UNITED STATES PATENT AND TRADEMARK OFFICE

APPLICATION NO.	FILING DATE	FIRST NAMED INVENTOR	ATTORNEY DOCKET NO.	CONFIRMATION NO.
09/839,001	04/20/2001	Harald Apfelthaler	KWO-17702/01	2739

This is a first office action for serial number 09/839001, entitled Terminal Plug for screwing a muntin bar to a spacer frame of in particular an insulated glass window, filed on April 20, 2001.

FIG. 5

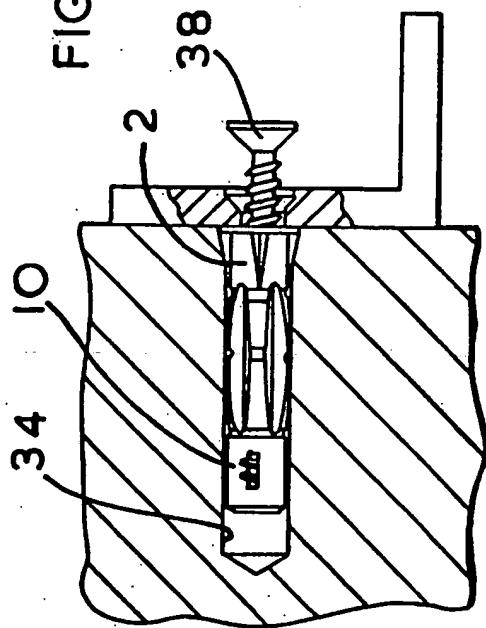
down to the bottom end of the plug (where 18 points to); the teeth (16) being such that a screw (38), by which the terminal plug (figures 1 and 2) is fixed to the spacer frame (34, 46), is passed through the slot (figures 4, 5, 8 and 9) and is provided with a tip (see figure 4 and attached figure 5) which abuts against the teeth to allow small expansions of the plug (column 1, lines 29-31); the upper end (2) of the slot (14) comprises a recess (see attached figure 2) passing through the flange (4) of the terminal plug to engage the surface of the work piece (column 2, lines 66-68); and, the recess is formed by a cone (see attached figure 2) followed by a cylindrical hollow space (column 3, lines 9-11) to allow the screw to be inserted into the plug. It would have been obvious to one having ordinary skill in the art to provide the longitudinal slot with the limitations above of Anquentin's plug with the plug of Governale in order to increase the strength of the connection of the screw/nail of the plug and to hold the plug more securely within the material provided as well as increase the utility of the plug with varying materials (column 3, lines 49-51, column 4, lines 10-13 and lines 33-35).
